Flood Risk Assessment and Drainage Strategy Addendum Report

Project name Land West of Turners Hill Road and South of Huntsland, Crawley Down
Project no. 1620011691 - 014
Client Wates Developments Ltd
Version 1.0

This Addendum Report is in response to comments from the Lead Local Flood Authority (LLFA) dated to the 26th of February 2025, regarding applications DM/25/0014 and DM/25/0015, and the requested further information:

Table 2.1: Huntsland Roadside Ditch Photographs

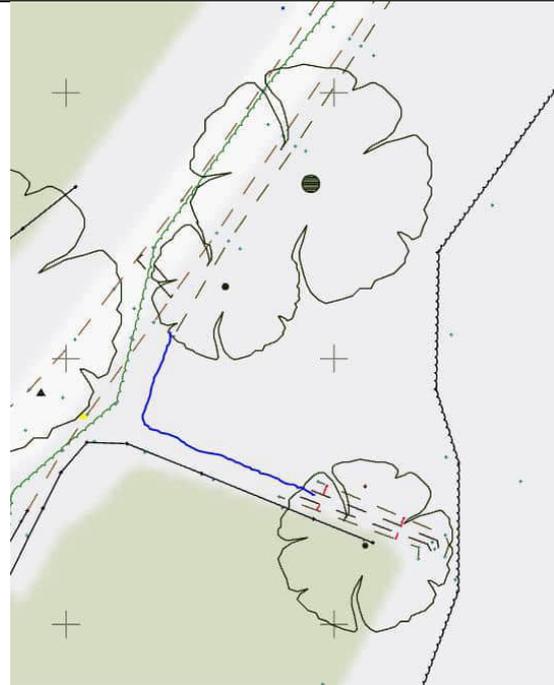
7. *For the surface water sewer required to deliver flows from diverted ditch off Huntsland to existing watercourse, further information is required. The topographical survey suggests the ditch is not connected to the ditch that it is proposed to connect to. The use of a surface water sewer to connect the ditches would be unlikely to gain ordinary watercourse consent.*

It is unclear why the topographical survey does not show the full extent of the roadside ditch off Huntsland as it is diverted toward Field 5. It is considered that at the time of survey vegetation growth prevented access to the area.

Table 2.1 below shows photographs of the ditch in this location alongside an extract from the topographical survey to aid in visualising the ditch at this location.

Blue line drawn over topographical survey indicates reality of ditch route as observed onsite.

As noted in the previously submitted Drainage Strategy, a surface water sewer is only proposed to be installed at the downstream end of this diverted ditch where no connection is currently present. This proposed sewer would divert flows across the southern end of Field 5 and would bypass the proposed surface water attenuation features proposed for the Field 5 surface water drainage strategy, before ultimate discharge to the existing watercourse between Fields 5 and 6. Drainage from this location off Huntsland would not therefore form part of the surface water storage requirements for Field 5.

Figure Title
EA Surface Water Flood Mapping - Future Scenario

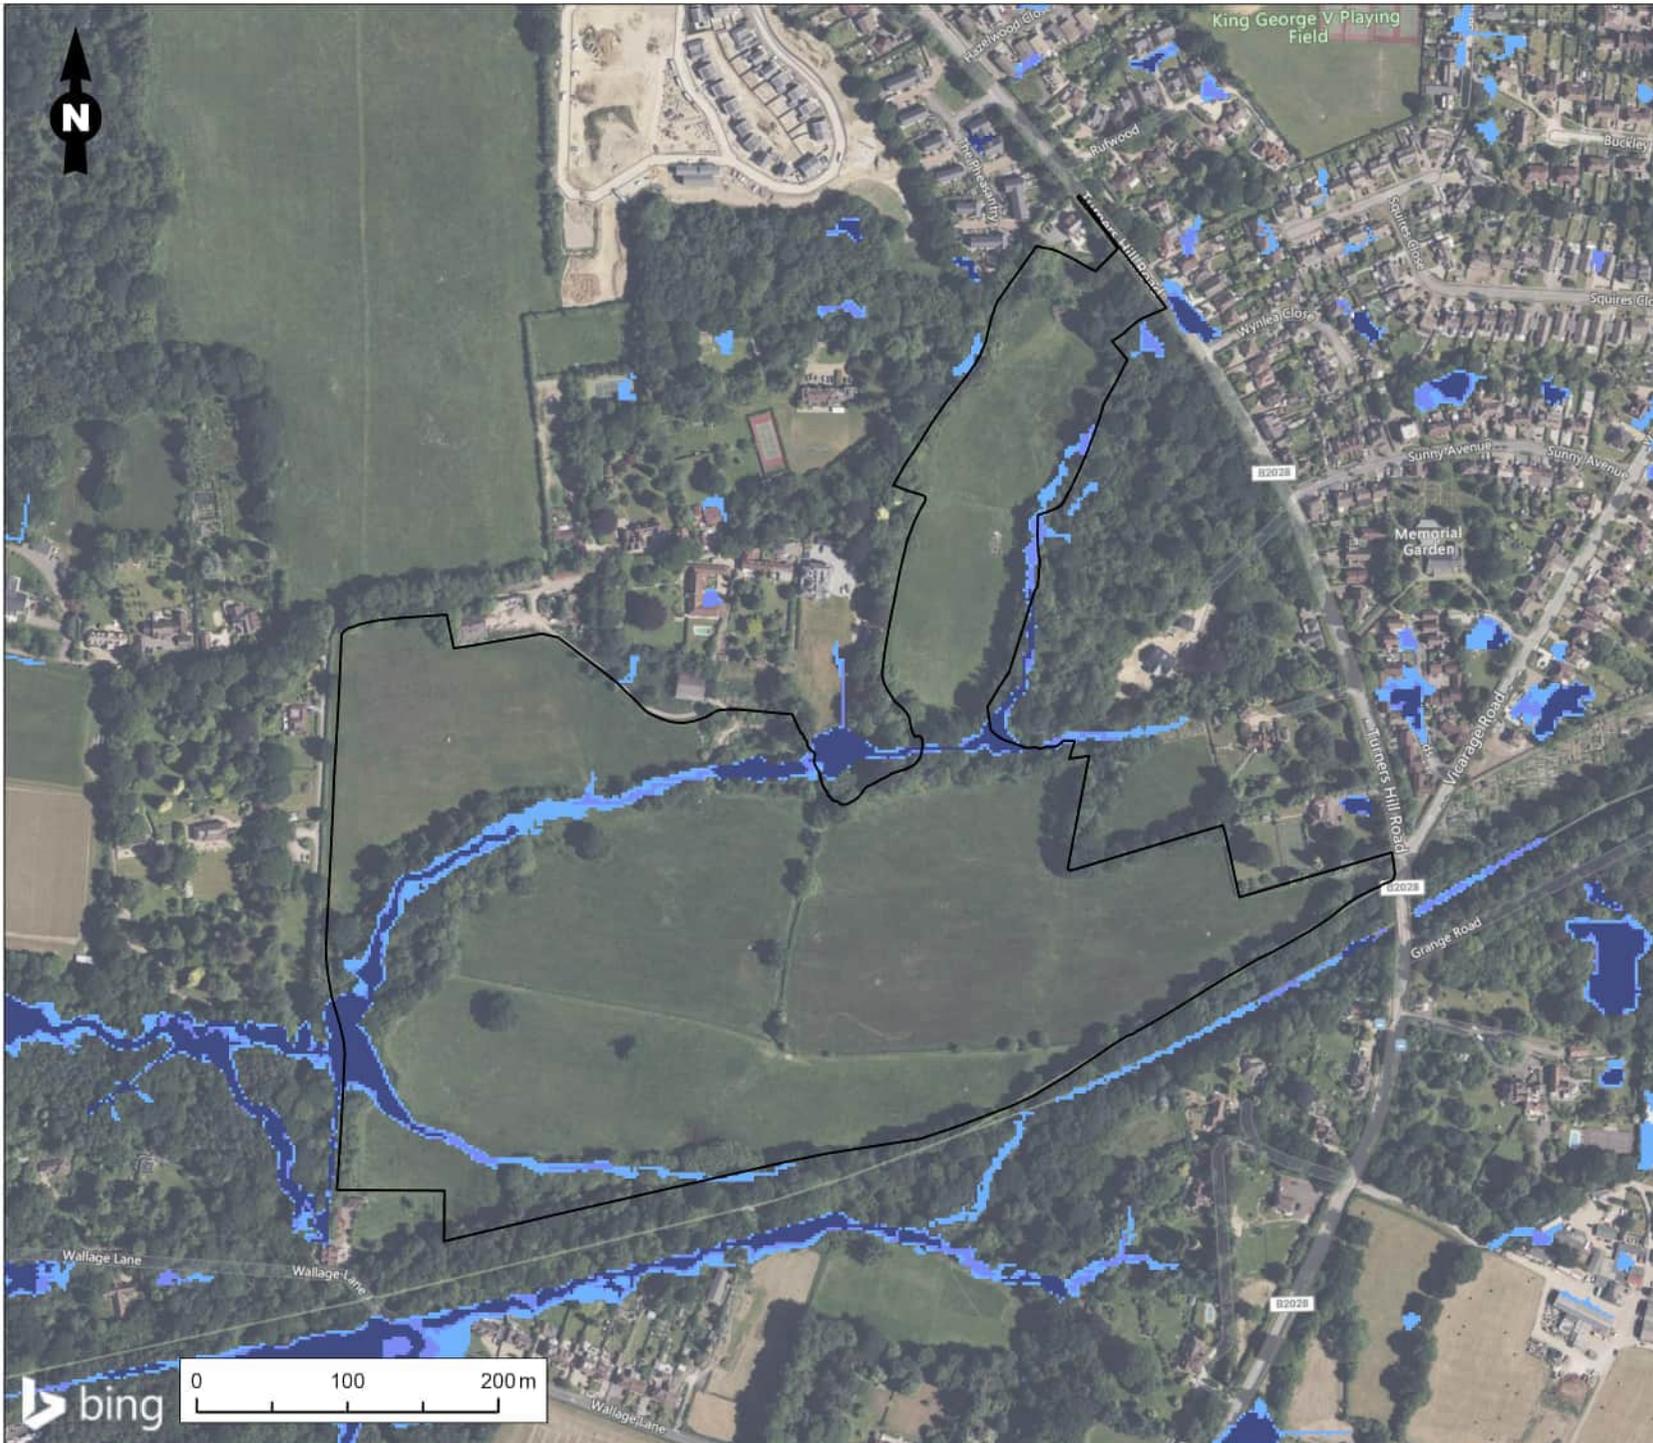
1. *The Environment Agency released updated flood risk mapping following the new National Flood Risk Assessment (NaFRA2) in early 2025. The updated mapping uses new and improved methods to assess flood risk. The Risk of Flooding from Surface Water mapping suggests that the mapping more accurately reflects conclusions in the FRA. We request an updated FRA including the updated mapping.*

The updated surface water mapping is split between a present-day scenario and a future scenario which accounts for the potential impacts of climate change.

The updated mapping is shown to be more reflective of the topography of the site, with existing watercourses/ditches now picked up as potential surface water flow paths where previously these were incorrectly identified in the mapping as flowing across developable areas of the site. The updated mapping further supports the conclusions detailed above regarding the previous surface water mapping. It is noted that under both scenarios, no area intended for the construction of proposed dwellings is now indicated to be at risk from surface water flooding.

The updated mapping is presented in Figures 3.1 and 3.2 at the rear of the report.
